**CONTRACT
CHANGE
ORDER**

CCO No.: 002

PROJECT	PROGRAM NO.	CONTRACT NO.	SUPPL NO.	CHANGE REQUESTED BY:
Alder/Randall Street Improvement Project		P-140809		<input type="checkbox"/> OWNER <input type="checkbox"/> CONTRACTOR
TO: Rick Garabedian, JM Olvera TITLE: Storm Drain Laterals 3, 4, and 6 Revisions				OTHER ID LPPSB1L-5205(028)

(RFP-003) Storm Drain Laterals 3, 4, and 6 Revisions:

NOTE:
DETAIL A TO BE APPLIED TO ALL SURFACE CONNECTIONS BETWEEN NEW AND EXIST CULVERT

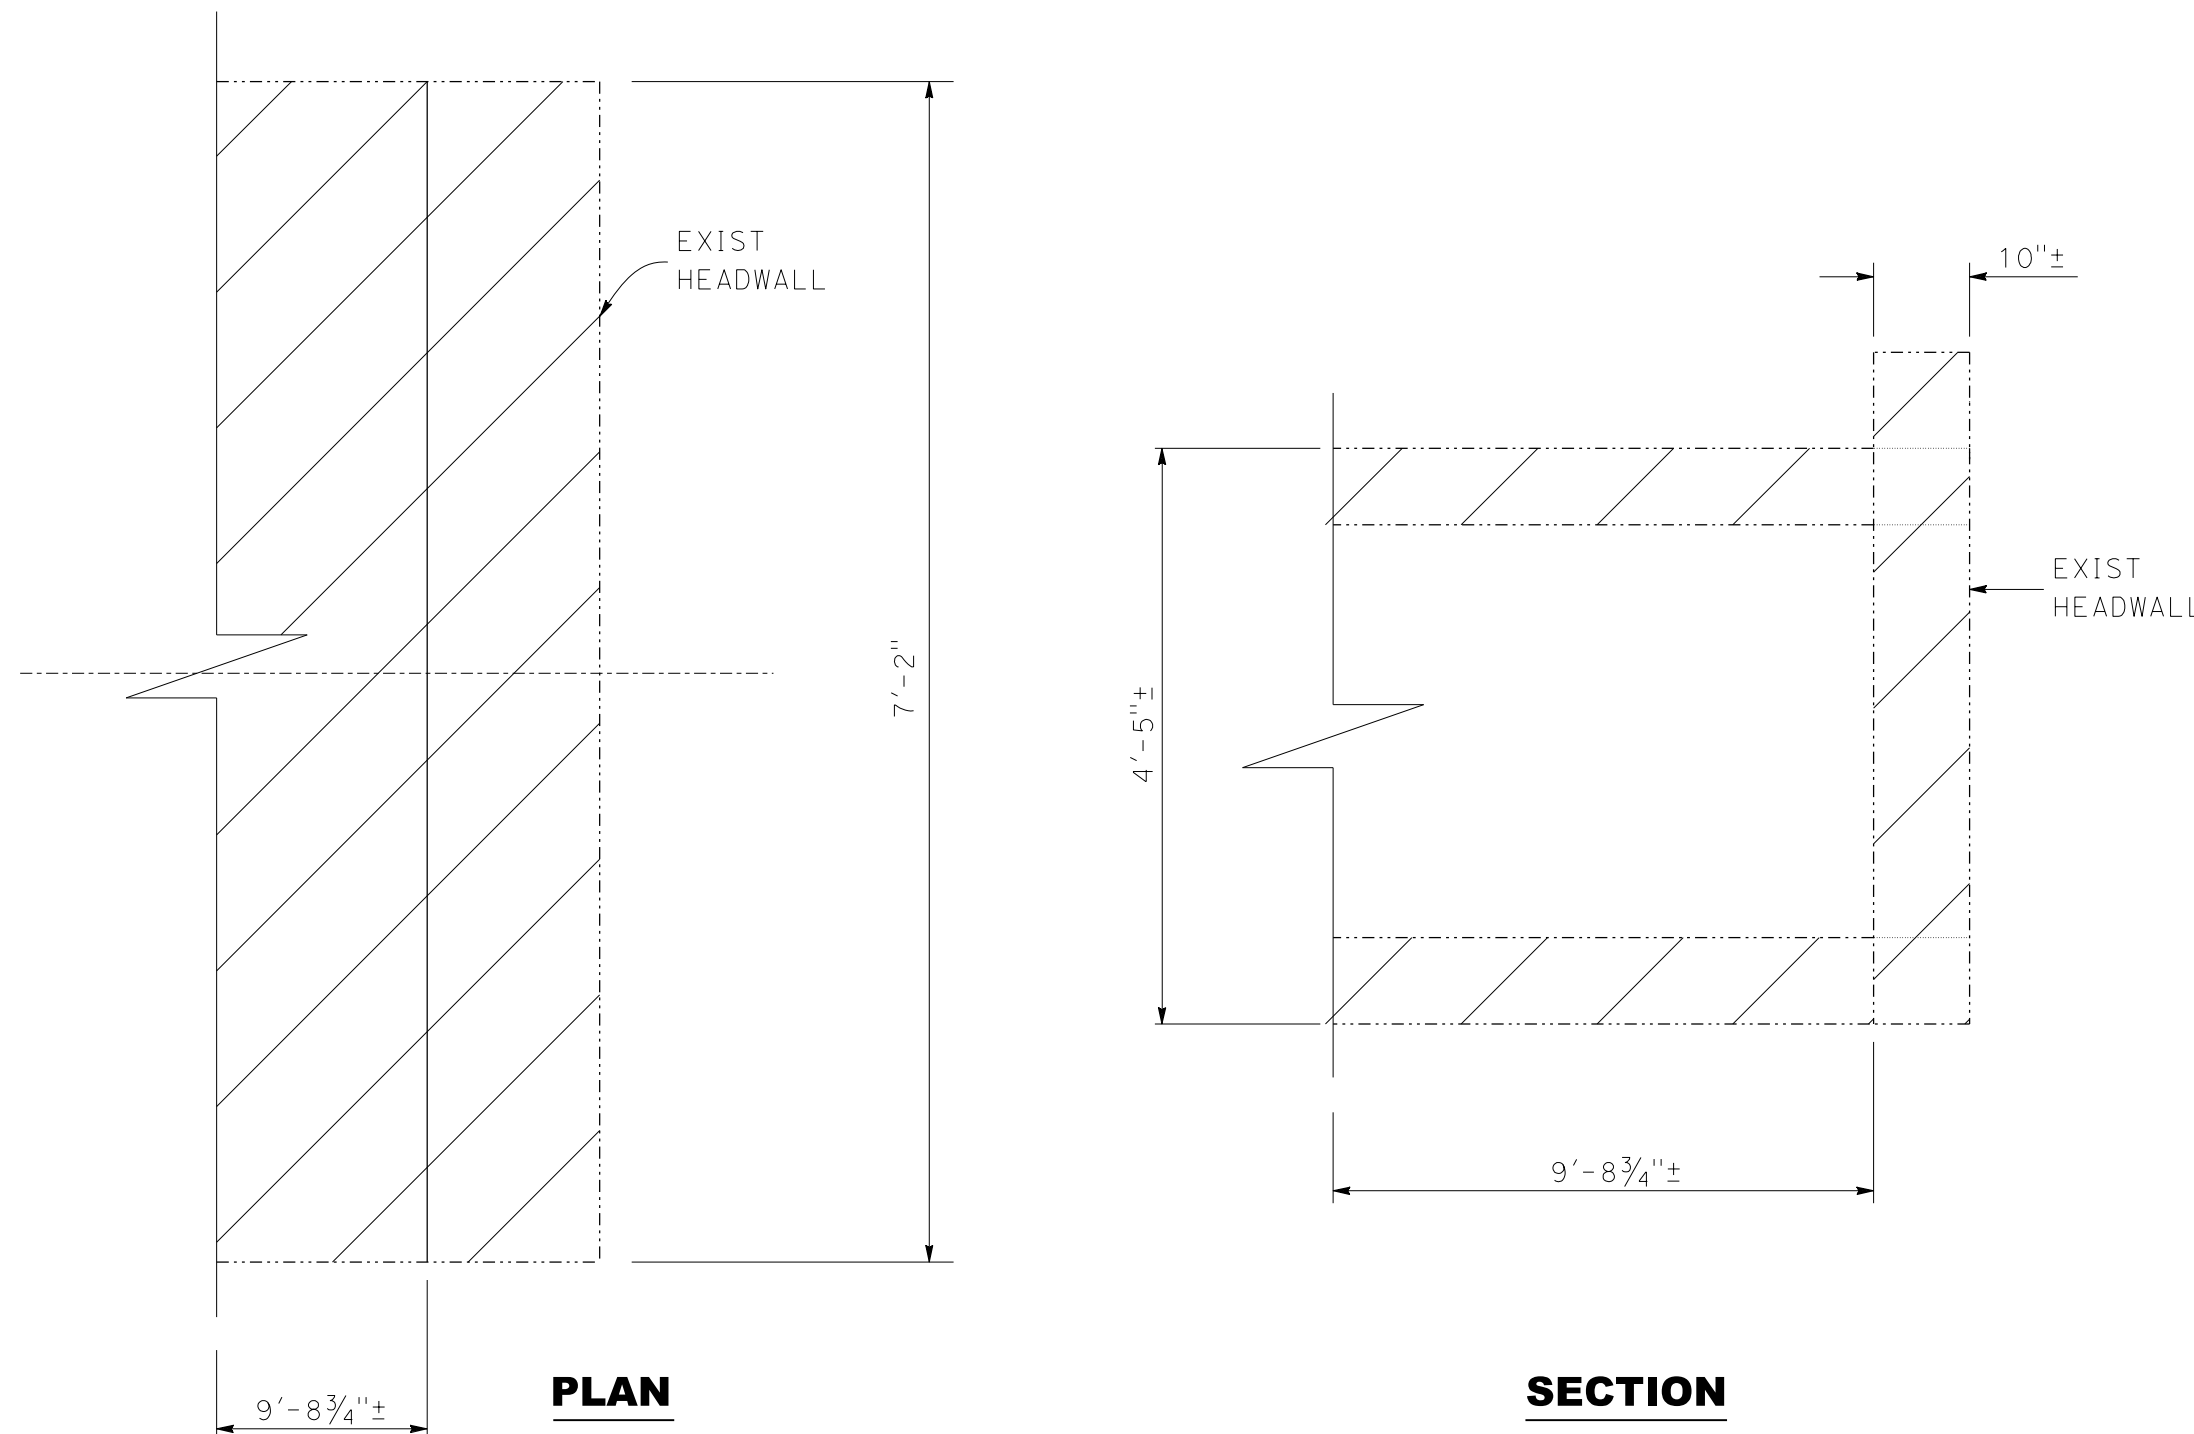
- 1) Remove a segment of the existing double RCB box at Station 132+23.32 from 10 ft right to the existing headwall as shown on Sheet 10 of 105 Rev. 01.
- 2) Construct the new Lateral 6, cast in place double RCB box at Sta. 132+23.32, from 10 ft. right to approx. 19.7 ft. right as shown on Sheet 44A of 105.
- 3) Construct Laterals 3 and 4 to revised grades as shown on Sheet 44 of 105 Rev. 01.
- 4) Construct Junction Structure “RAN” 132+23.42 per details shown on Sheet 44B of 105 (Modified from SPPWC Standard Plan 320-2).
- 5) Construct Junction Structure “RAN” 131+47.89 per details shown on Sheet 44C of 105 (Modified from SPPWC Standard Plan 320-2).
